DATE: November 10, 2016

SUBJECT: Revised Document Plans - Addendum #1

AC BOARDWALK HALL RESTROOM RENOVATION

2 ENLARGED FAN ROOM #16 PLAN M-102 1/4" = 1'-0"

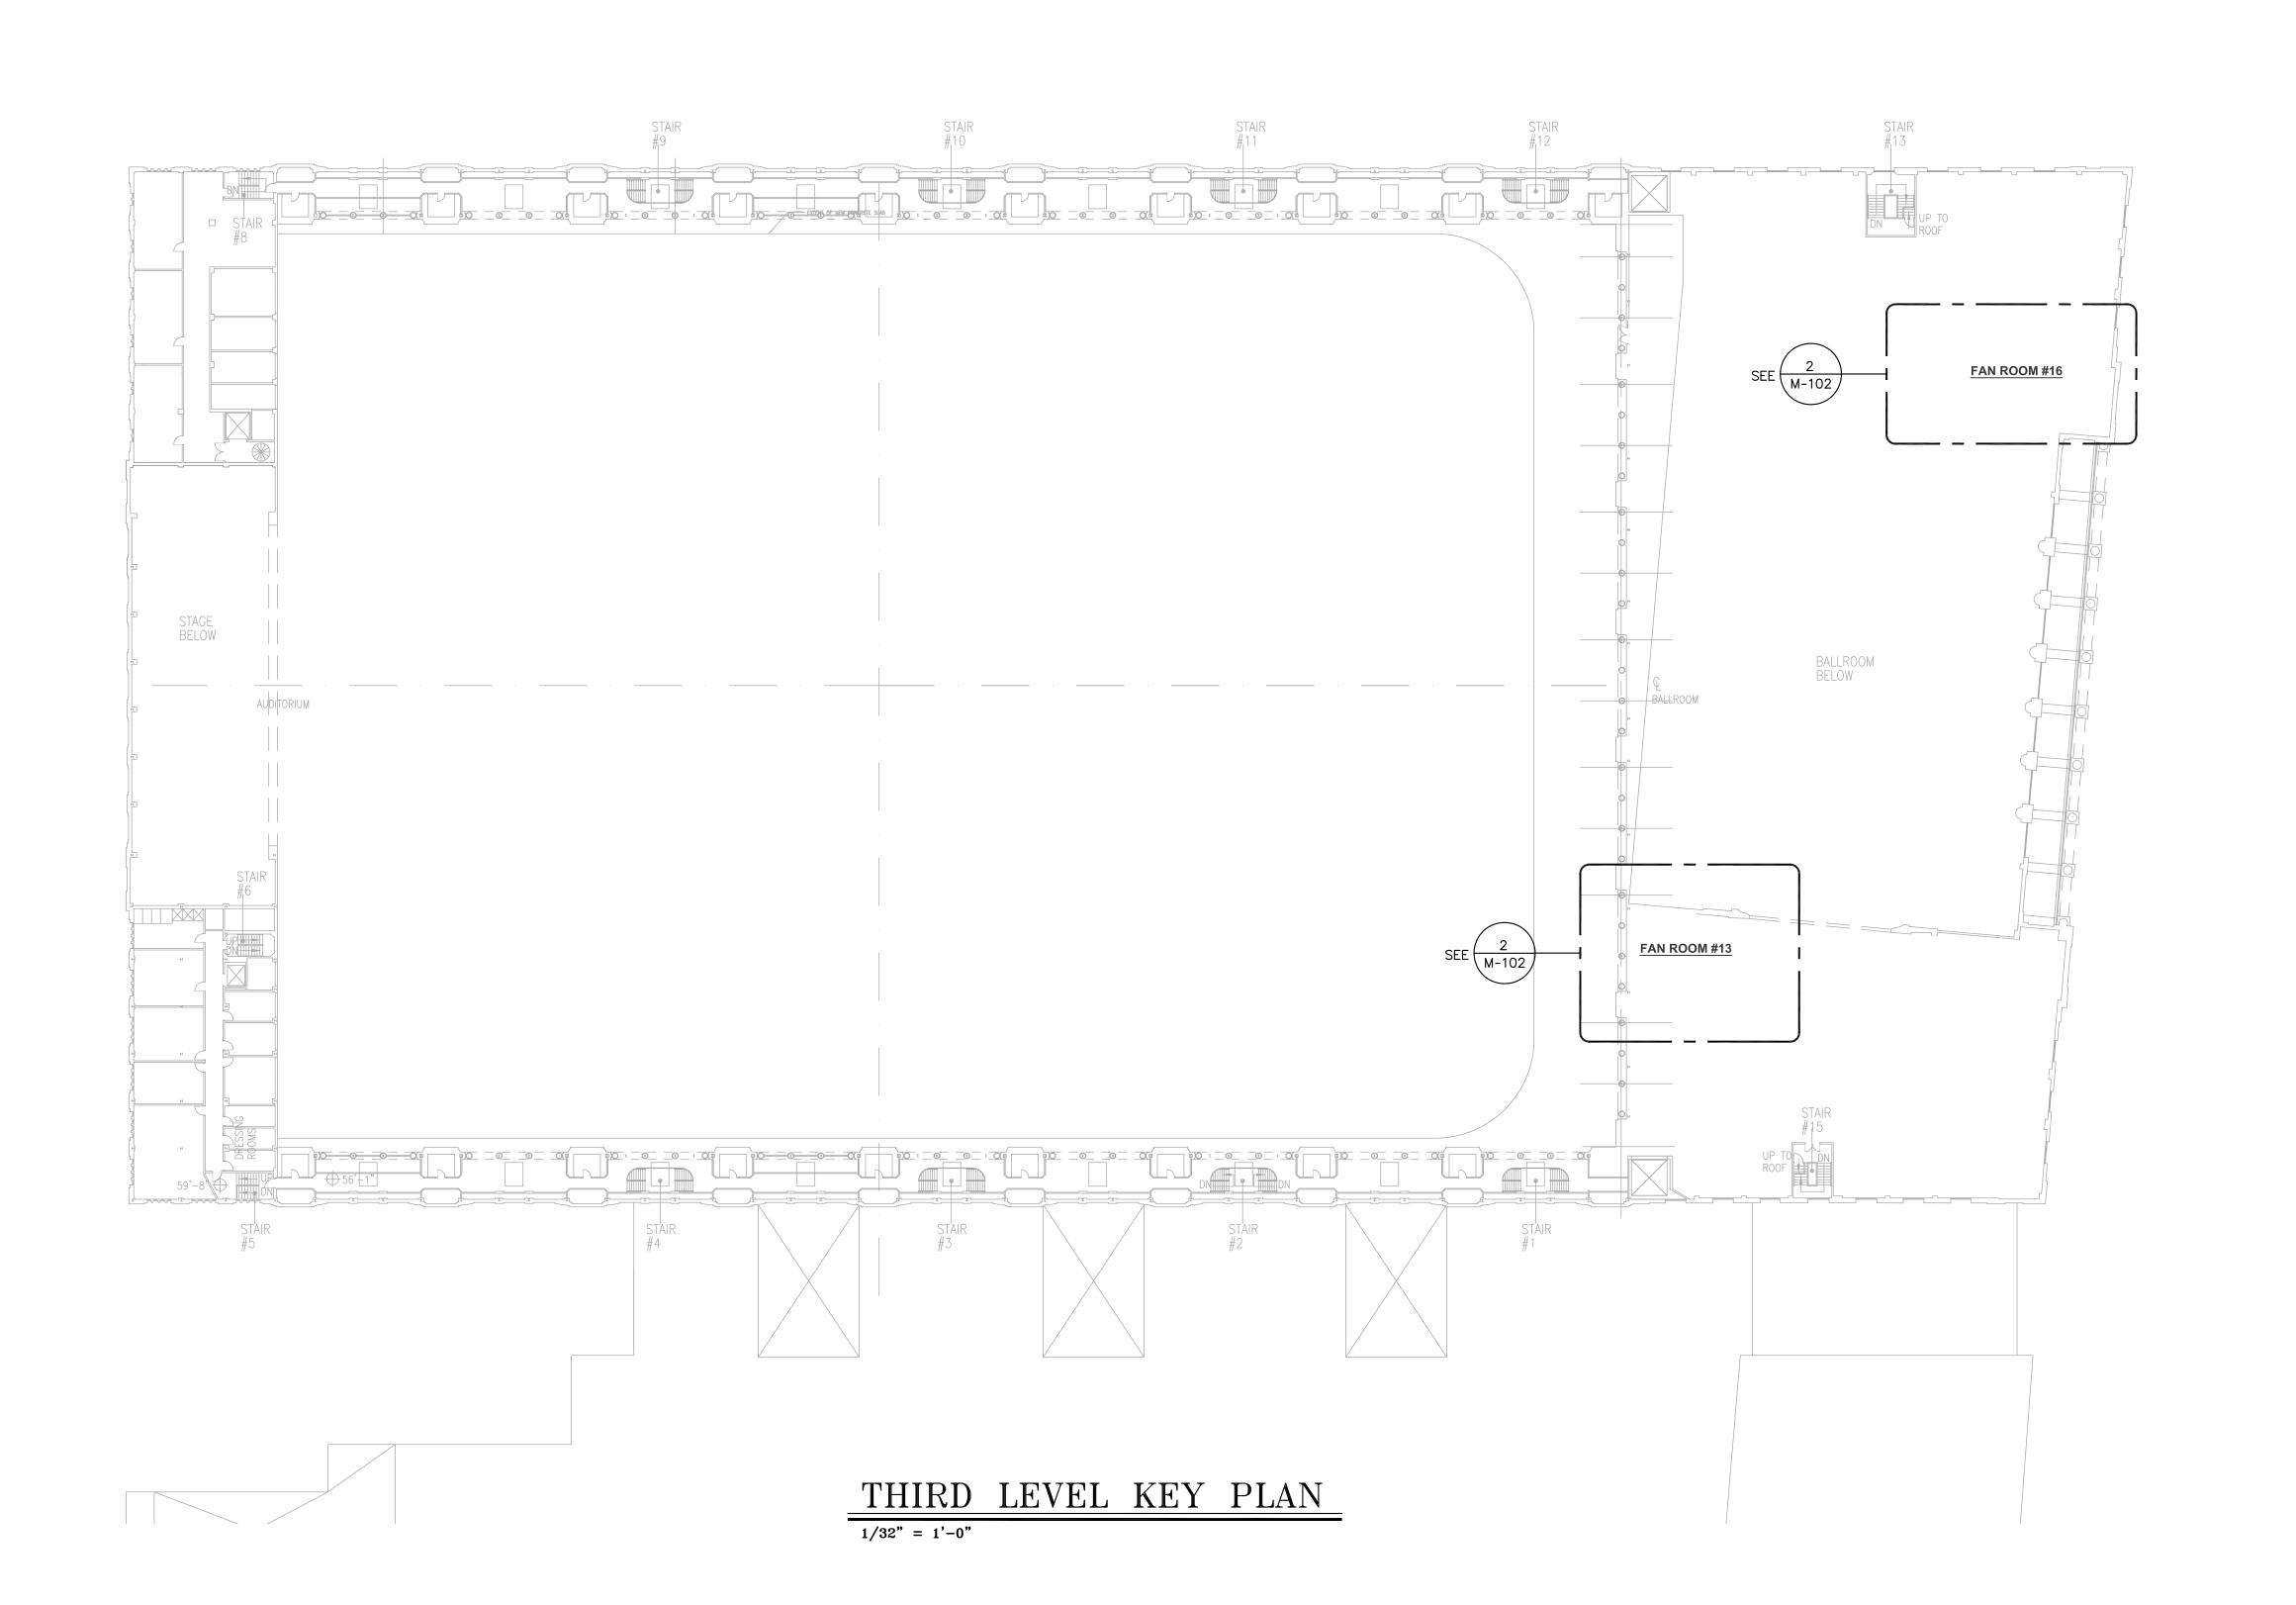
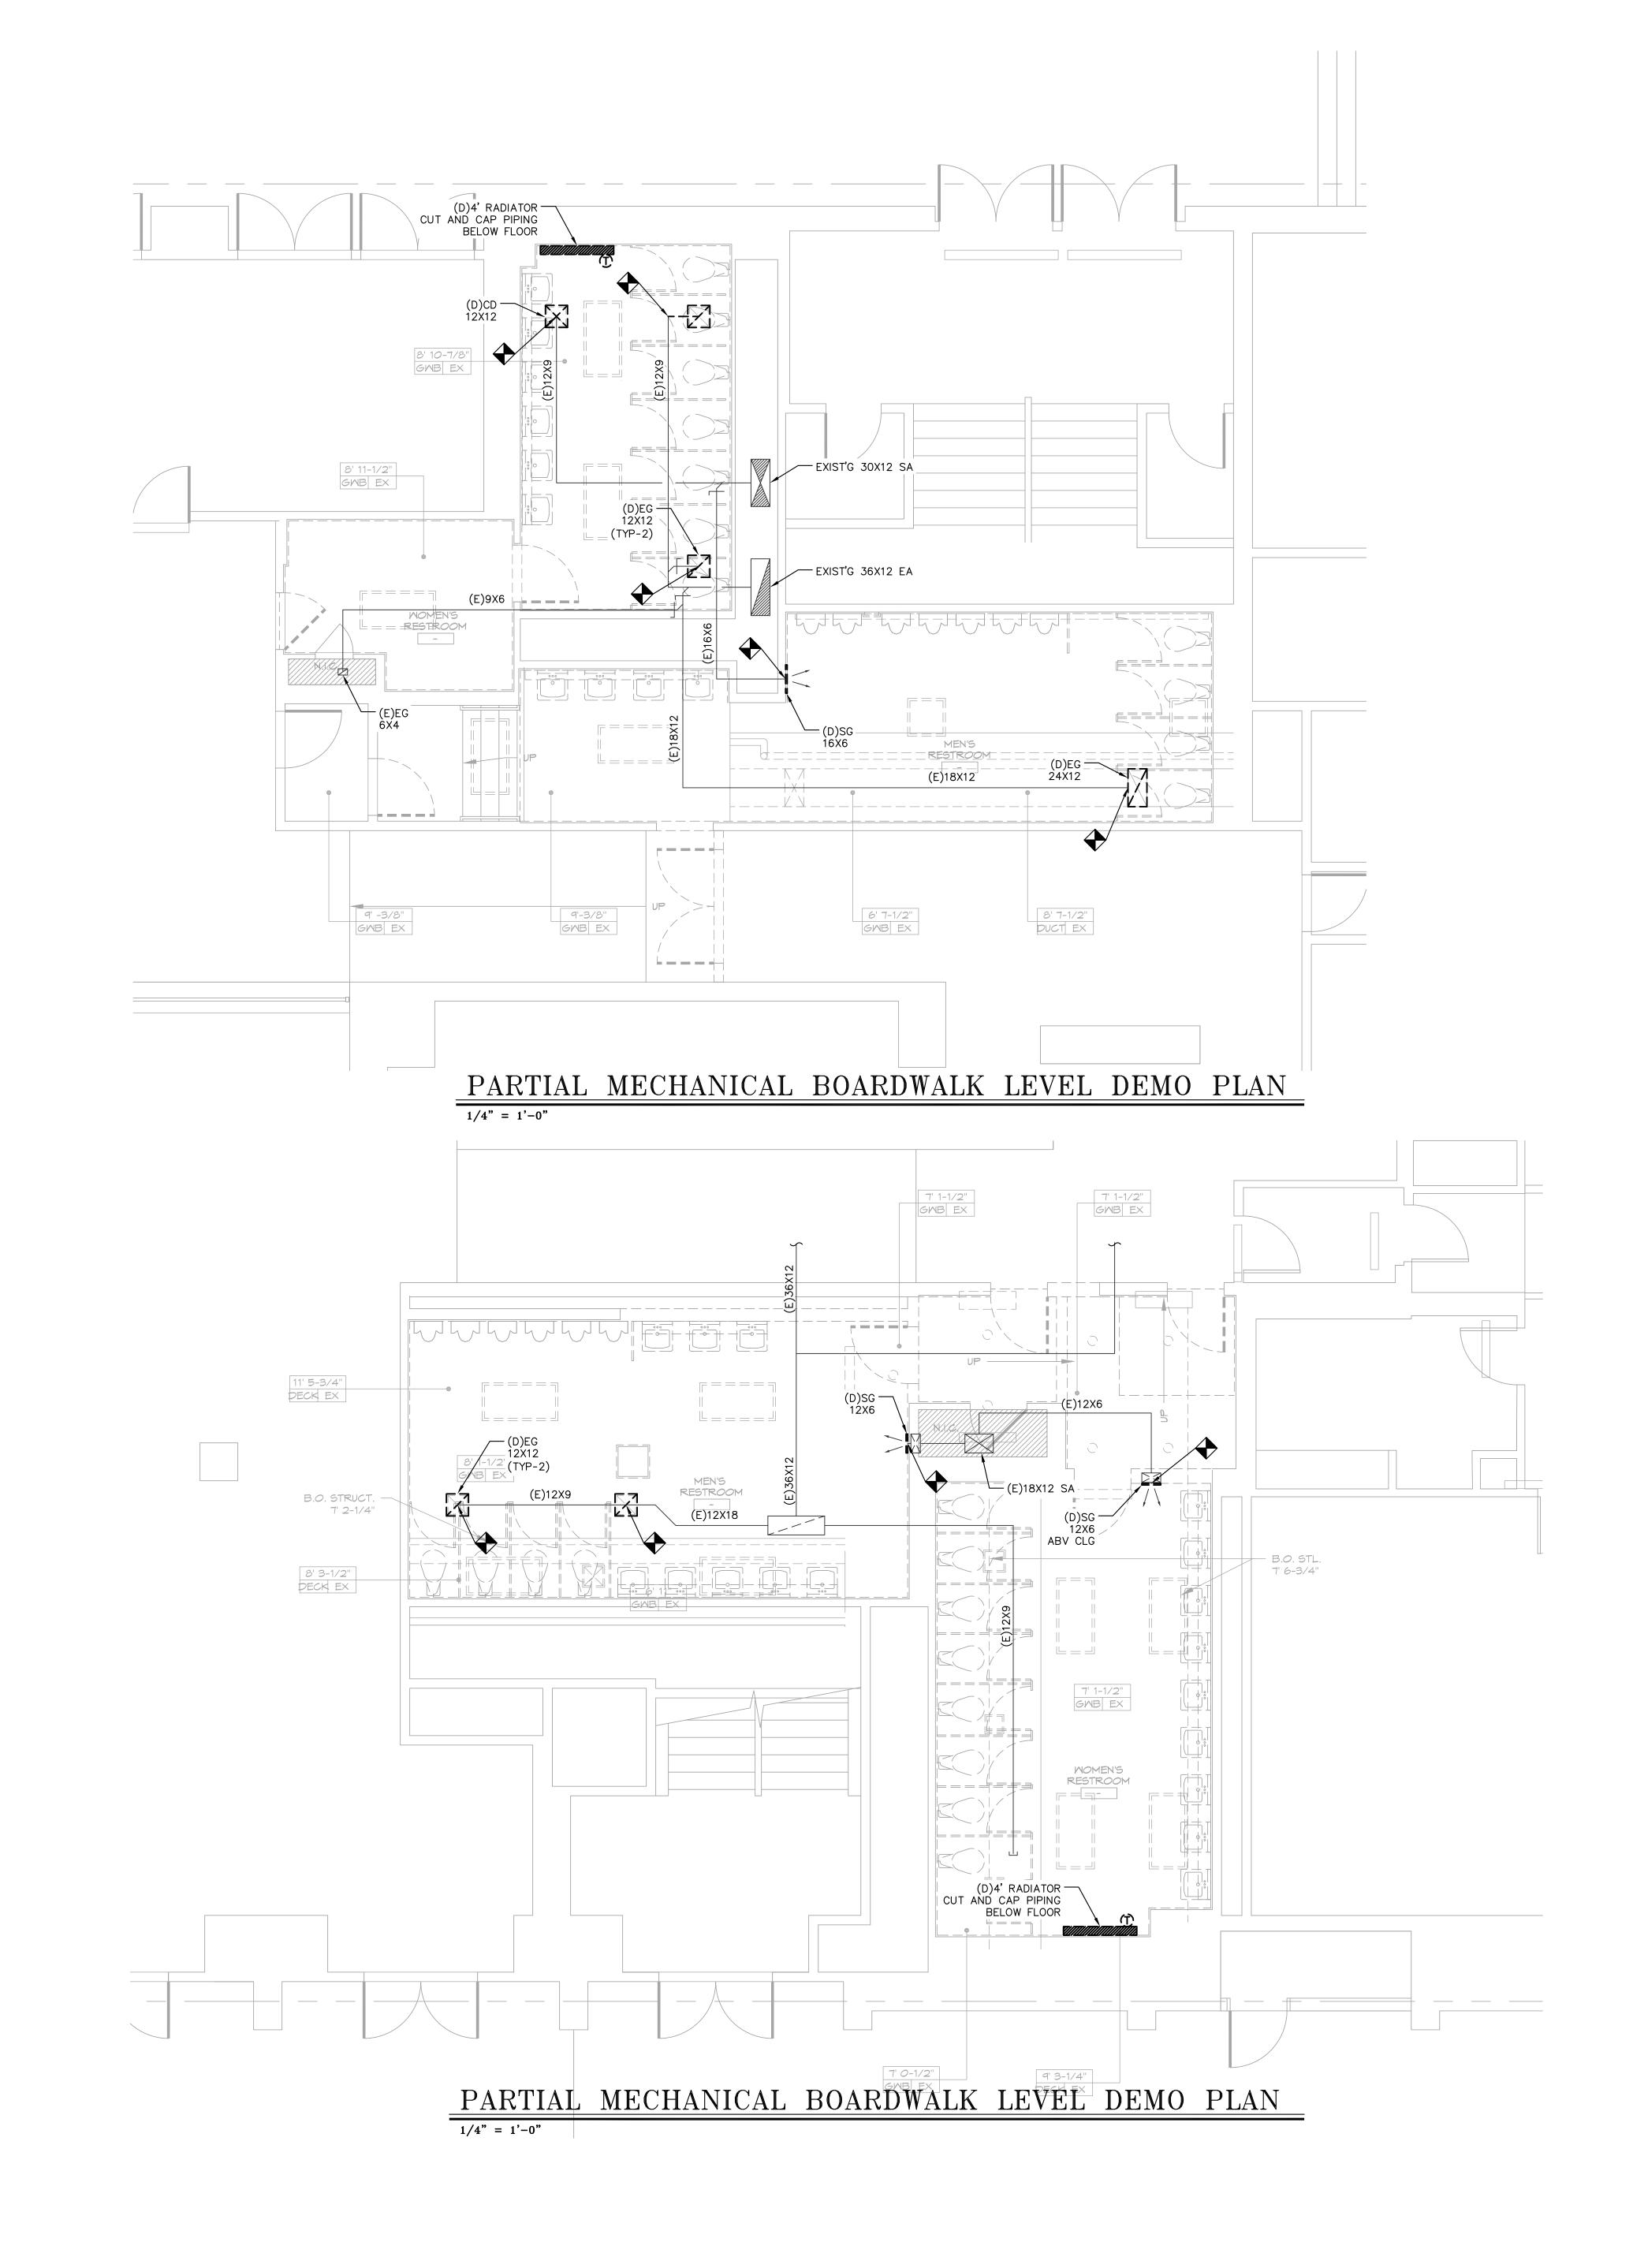
1. There was an error on the MEP set. MEP set M-101 and E-001 was used twice. The attached is a revised plan set correcting this error.

DRAWING TITLE:		
COVER	SHEE	Γ
DRAWN BY:	SB	DRAWING NO.
REVIEWED BY:	CM	
PROJECT NO.		L AC-000
l 15243.00).001

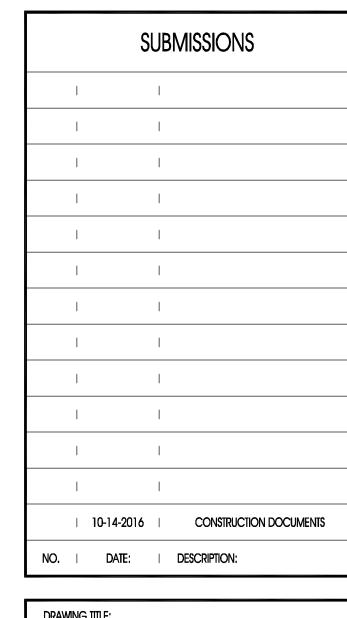
2. The attached is a revised drawing list due to the error in the MEP set.
